**Amendments to the Drawings:**

**REMARKS/ARGUMENTS**

This is in response to the Office Action mailed July 3, 2006. This response is considered to be timely since it is being filed on August 3, 2006 and the shortened statutory period for reply was set to expire one month from the mailing date of the communication.

FIG. 6

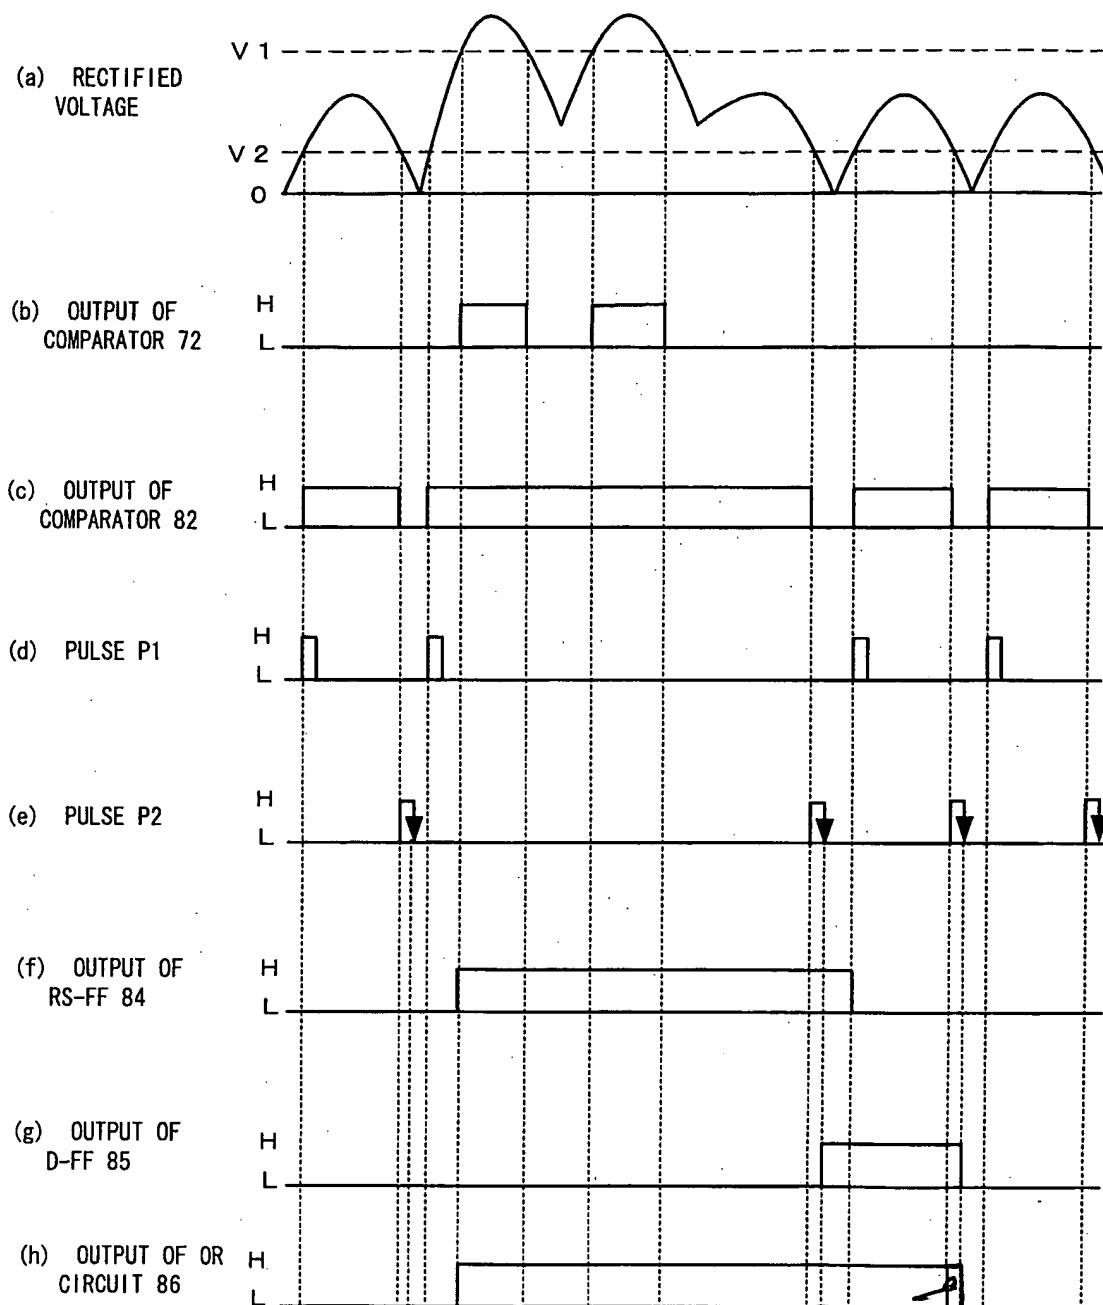
The attached sheet of drawings includes changes to Fig. 6. This sheet, which includes Fig. 6 replaces the original sheet including Fig. 6.

A redlined copy of Fig. 6 showing the changes is also attached.

Applicant amends Fig. 6 to correct the illustration of waveform (h) representing the output of OR circuit 86. A redline annotated drawing illustrating the amendment is attached.

In particular, the Specification at page 18 at ll. 4-8 supports the amendment to the figure. The Specification, at page 18, ll. 4-8 states:

Meanwhile, when the power source voltage becomes 100 volts, the output signal of the comparator 72 is fixed to "L". Accordingly, the RS-FF 84 is not set and the

output signal of the RS-FF 84 becomes "L". At timings at which the pulse P2 falls, the output signal of the D-FF 85, which latches "L" of the output signal of the RS-FF 84, becomes "L". At these timings, the output signal of the OR circuit 86 changes to "L".

Thus, the Specification clearly supports the output of the OR circuit 86 falling to a low level (L) at the fall of pulse P2 and when the output of the D-FF 85 becomes low (L).
